**Idaho Lower Snake River Compensation Plan State
Operated Hatcheries**

Clearwater, Magic Valley, McCall, and Sawtooth Fish Hatcheries
Assessments and Recommendations

Final Report, Appendix D:
Complete Text of Comment Letters Received from Stakeholders

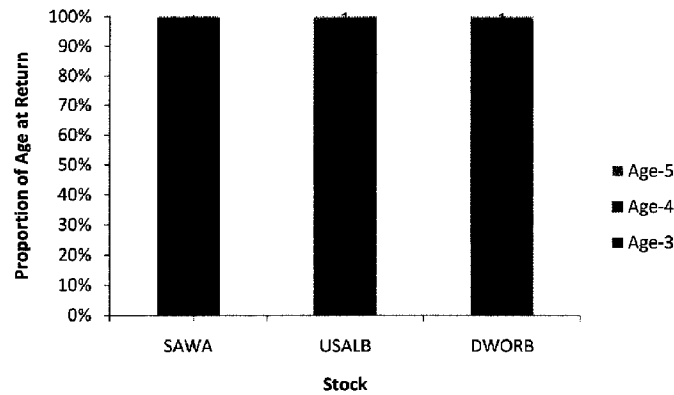
USALB maintain a life history similar to that of DWORB and return predominantly as age-4 adults (Figure 1 and 2). These life history patterns contrast sharply with that of SAWA in which only a small proportion of fish return as age-4 fish. USALB males returned as age-3 fish more frequently than females; however, this pattern exists in the DWORB as well. Although few in number, age-5 fish were only observed in USALB and DWORB stocks.
